Access Compliance Report

Public Rights-of-Way

(Curb Ramps)

Intersection ID: 29301	Main Street: PERKINS_RD	Cross Street: FAR_WEST_DR	Location: W
ADA ID: 1E919136815E	Ramp Type: Perp	Initial Pass/Fail: Fail	Overall Compliance: No
Severity Score: 46.25			
Codes/Mitigation Info/Possible Solution		Field Measurements/Component Compliance

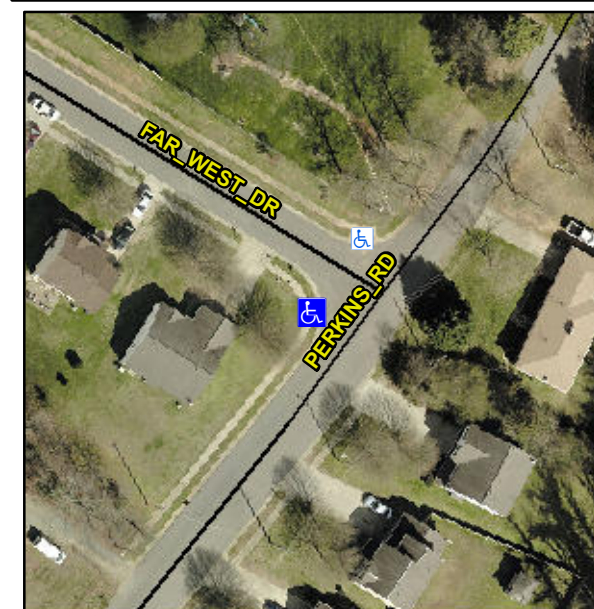
Not Found, R304.5.1, R304.2.2, R304.5.3

Compliance	Description	Data	Compliance	Description	Data
N/A	Ramp Length (in)	48.0	No	Ramp Slope (%)	10.3
No	Ramp Width (in)	46.0	No	Ramp XSlope (%)	7.1
N/A	Flare Type LT	N/A	N/A	Flare Type RT	N/A
N/A	Flare Slope LT (%)	N/A	N/A	Flare Slope RT (%)	N/A
N/A	Flare Traversable LT?	N/A	N/A	Flare Traversable RT?	N/A
N/A	Landing Length (in)	N/A	N/A	DWS Provided?	N/A
N/A	Landing Width (in)	N/A	N/A	DWS Contrast?	N/A
N/A	Landing Slope (%)	N/A	N/A	DWS Length (in)	N/A
N/A	Landing X Slope (%)	N/A	N/A	DWS Full Width?	N/A
N/A	Landing Curb? (Y/N)	N/A	N/A	DWS Offset (in)	N/A
N/A	Shared Landing?	N/A			
N/A	Gutter Ponding?	N/A	N/A	Gutter Slope (%)	N/A
N/A	Gutter Lip Ht (in)	N/A	N/A	Gutter X Slope (%)	N/A
N/A	Painted X Walk1?	No	N/A	Painted X Walk2?	N/A
	X Walk 1 Direction	To NE		X Walk 2 Direction	N/A
N/A	X Walk 1 Width (in)	N/A	N/A	X Walk 2 Width (in)	N/A
	X Walk 1 Slope (%)	3.5		X Walk 2 Slope (%)	N/A
	X Walk 1 X Slope (%)	5.7		X Walk 2 X Slope (%)	N/A

Remove & Replace Entire Ramp.
